# ATTACHMENT 2 - RESUBMITTAL

## COMMENT RESPONSE LETTER

NEW RIVERSIDE - STORE # 1062  
SC HIGHWAY 46 & E PARKSIDE COMMONS  
BLUFFTON, SOUTH CAROLINA

5 ROOF PERSPECTIVE

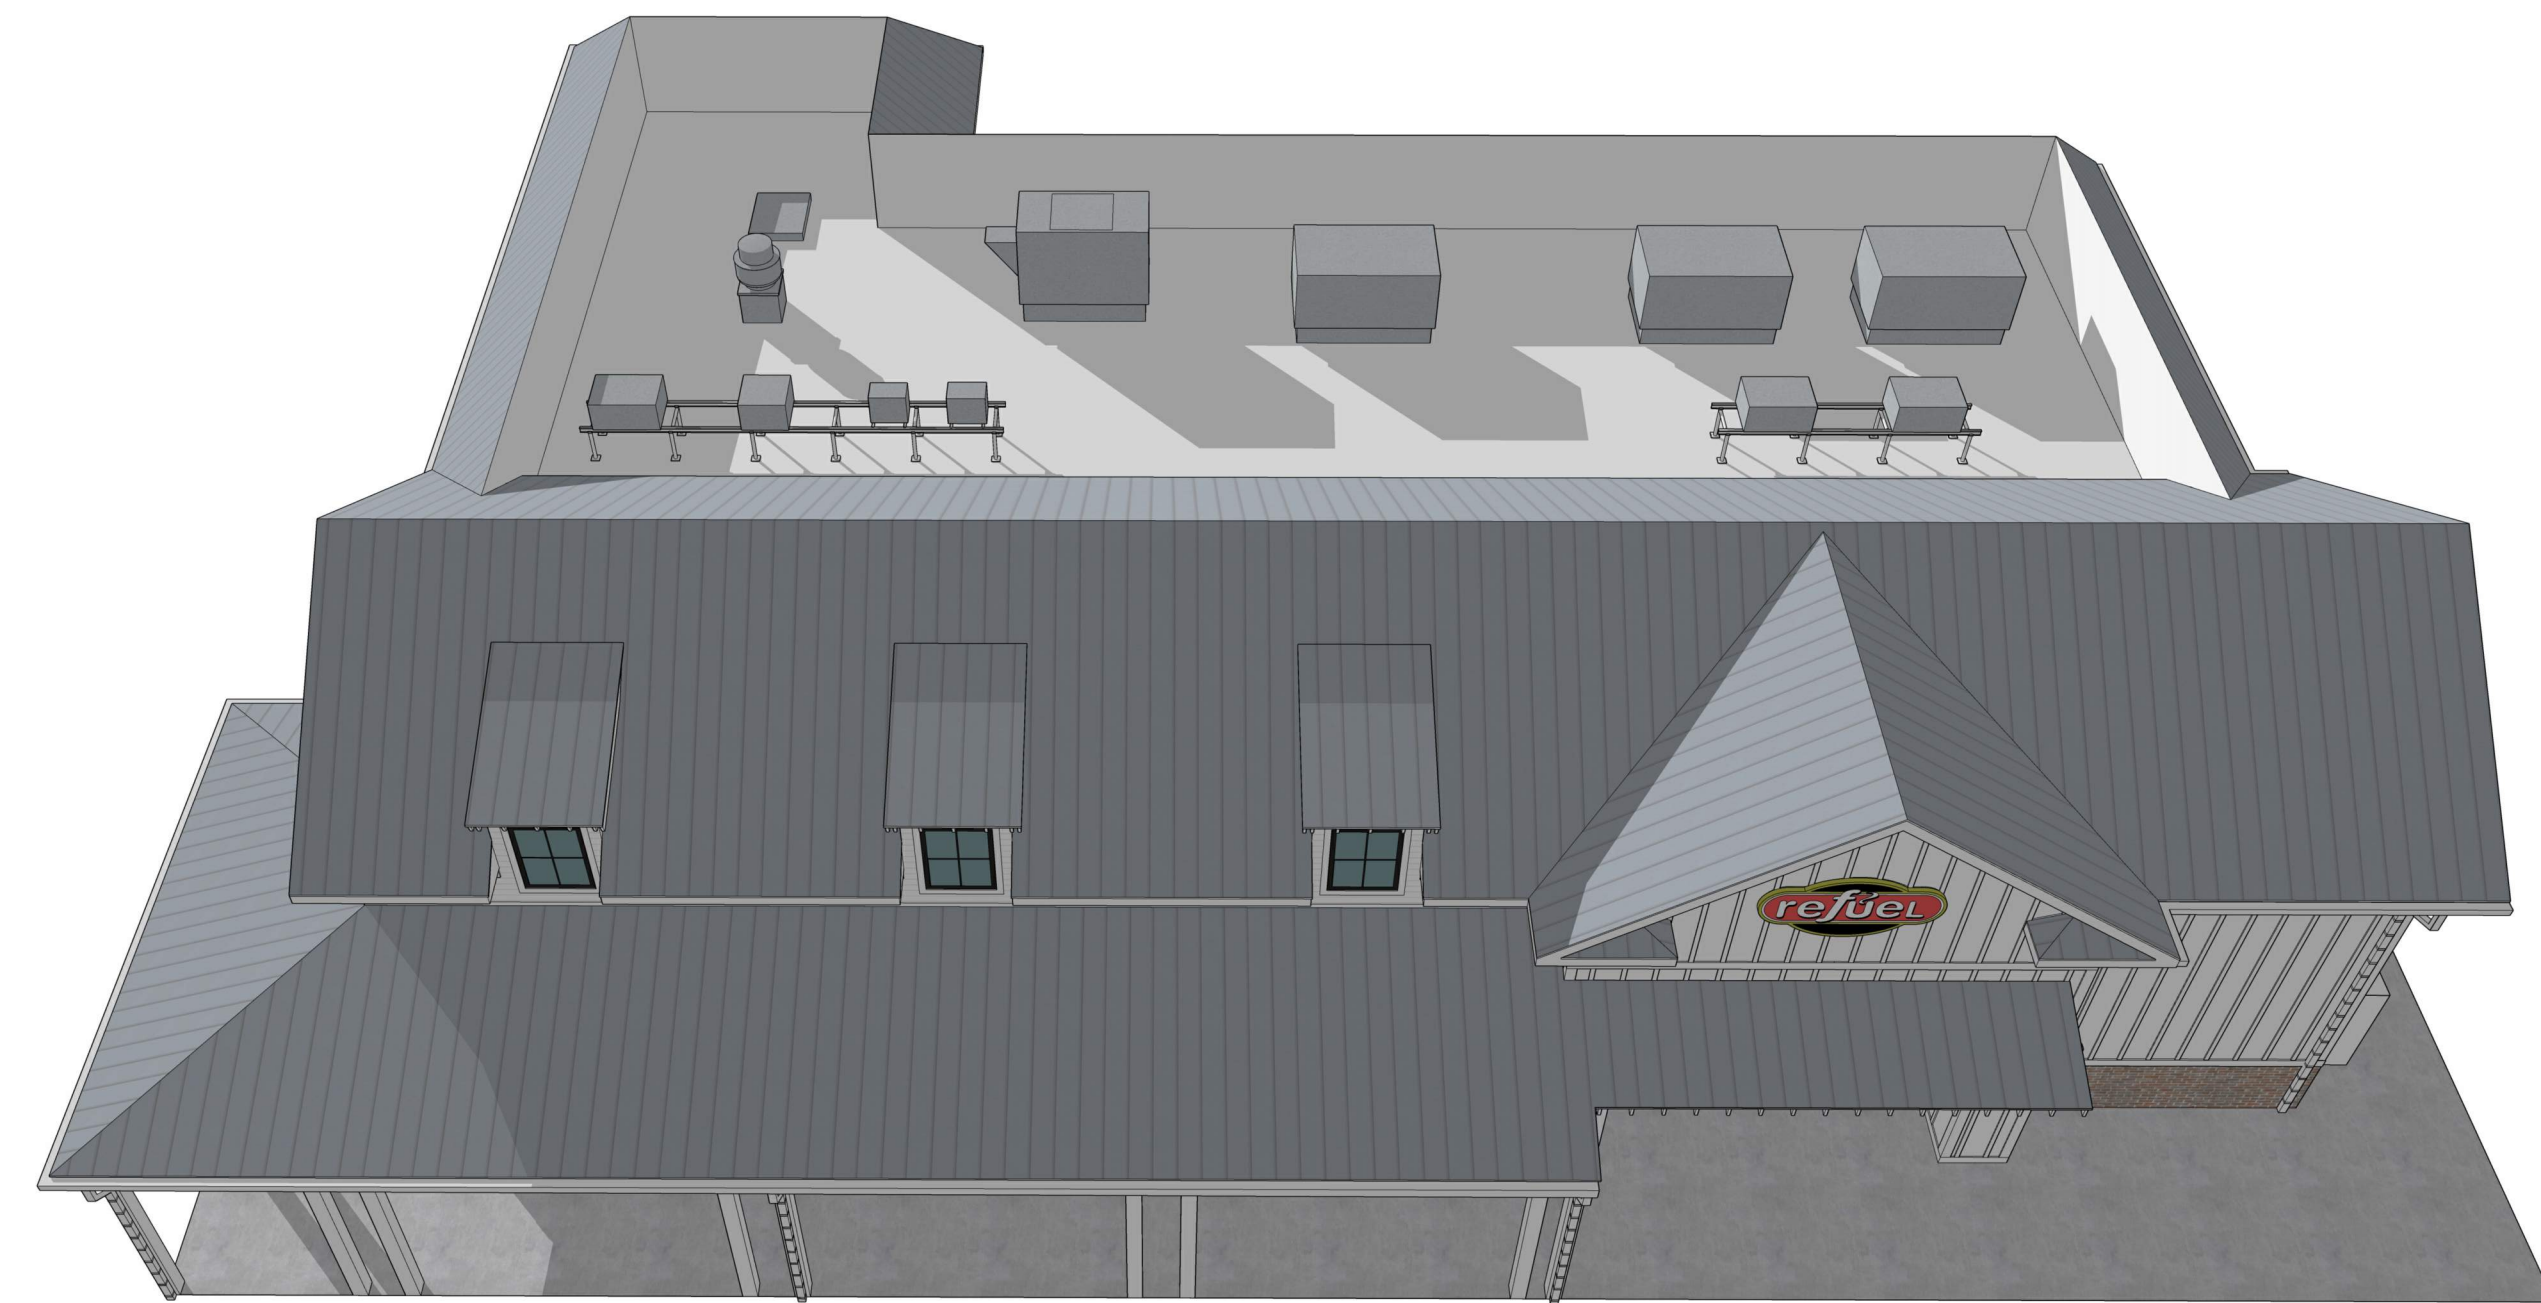
- d. Per Section 5.15.12(A), additional information must be provided regarding the location of proposed service yards and utilities, and if proposed on the roof, a roof plan provided as not enough information has been provided to ensure they will be screened from view. A roof plan must be provided to show mechanical locations as well as to provide a better understanding of the rooflines and how they will interact.

Response: Roof plan showing mechanical equipment locations has been added to submittal.

CONVENIENCE STORE ELEVATIONS  
NEW RIVERSIDE - STORE # 1062  
SC HIGHWAY 46 & E PARKSIDE COMMONS  
BLUFFTON, SOUTH CAROLINA

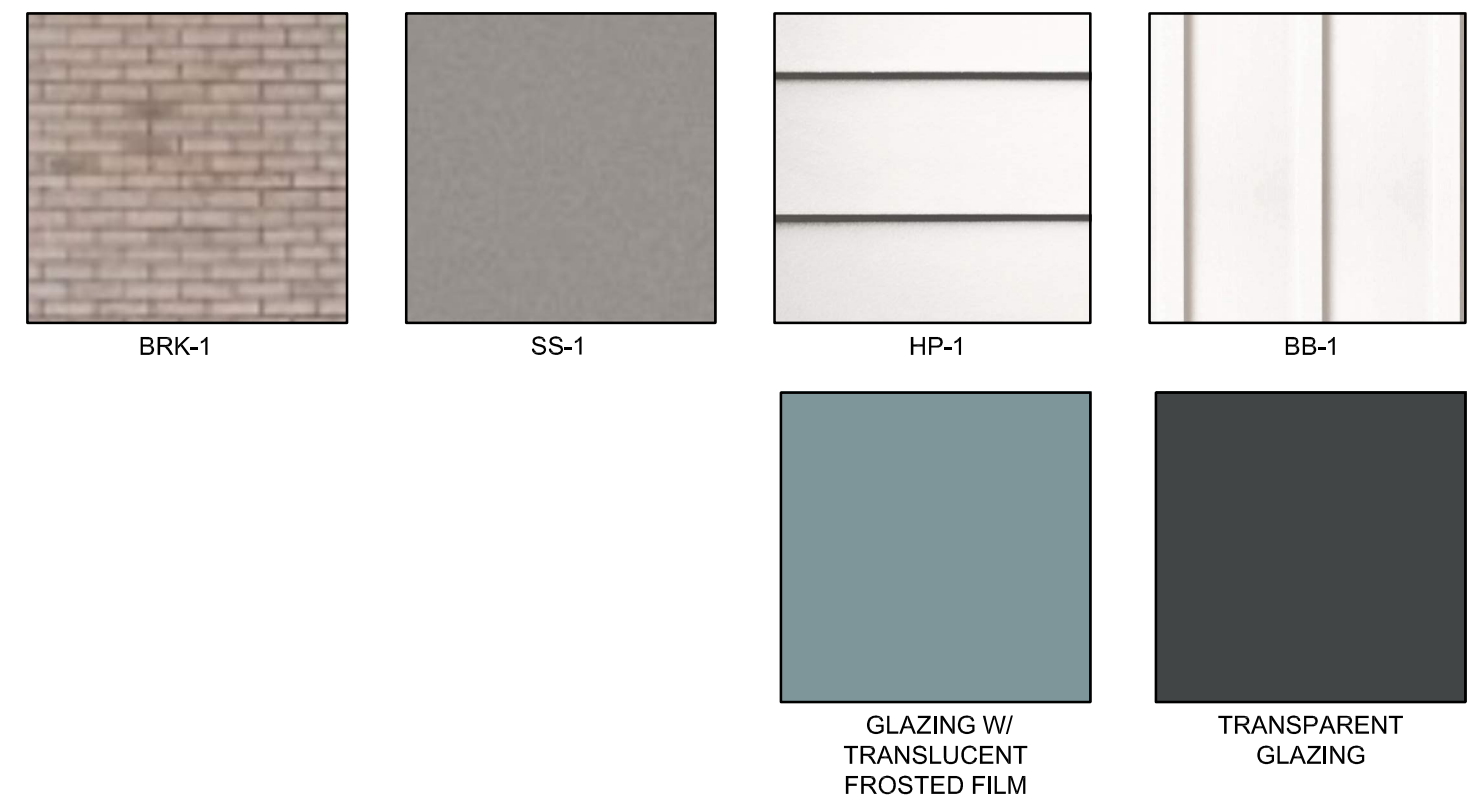
- a. Per Section 5.15.9.(C)(3), elevations showing the proposed propane enclosure and ice/outdoor coolers must be provided to ensure the design meets the requirements of the design standards. Or they must be relocated away from the front elevation (side and rear okay)

- e. Consider revisiting the overall height of the building to reduce the amount of blank wall space.

- f. Aim for more vertical/square window lites as horizontal lite patterns do not reflect Lowcountry vernacular as well.

- g. Consider breaking the plane of the roof where the parapet intersects the gabled portion of the roof. The elevations where this happens, and on the one in Beaufort, are more successful.

Response: Ice and propane have been relocated to side of building.

Response: Revised submittal has taken a combination of adjusting the height of the ceiling and adjusting the pitch of the roofs to reduce the amount of blank wall space. Enhanced landscaping has also been proposed along the east end of the building to help fill in some of the “blank” wall space.

Response: Elevations have been revised to reflect a more vertical window design.

Response: Plane of roof has been adjusted to reflect a more consistent roof line.
